### ADDENDUM NO. 2

# PROFESSIONAL BOULEVARD BRIDGE W5001 over ANTIETAM CREEK and ROAD GRADING STA. 21+23 TO 52+63 Washington County Contract No. RD-PB-244-10

Date Issued: OCTOBER 4, 2019

- ITEM 1.04 REVISIONS TO THE DETAILS AND EXHIBITS SECTION: shall be incorporated into the Bid Documents the following Details and Exhibits: (continued)
  - 2. ED-07 Pavement Sections

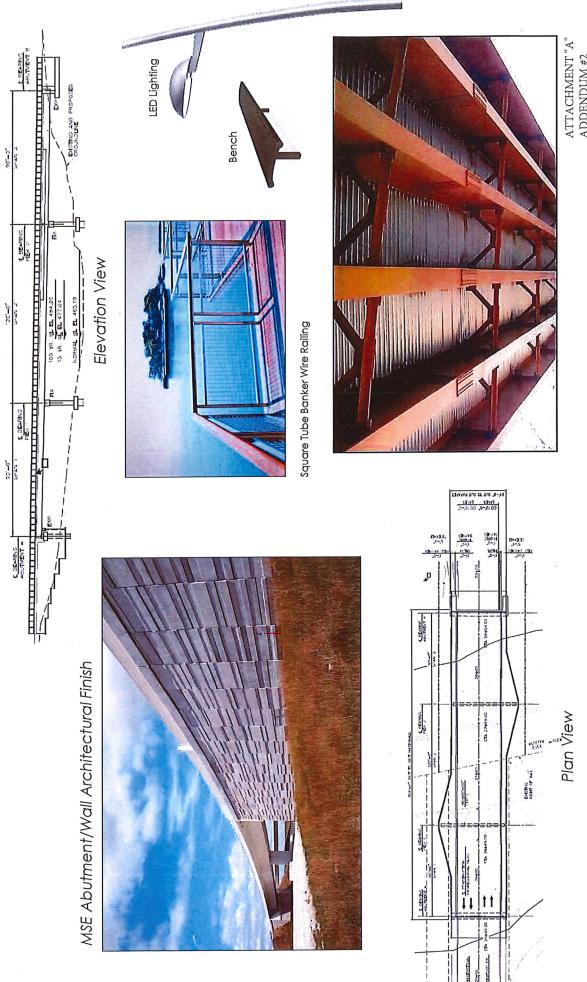
Add Sheet ED-07 to Exhibits and Details in the Bid Document Booklet

- The temporary driveway access (Station 22+00, right) to the Broadmore Senior Living Center shall be constructed using HMA for MOT at a depth of 4 inches.
- The permanent driveway (Station 22+70, left) to the Washington County Mental Health Center, Inc. shall utilize a pavement section including 6" GAB, 3" Base, and 2" Surface as shown on detail ED-07.
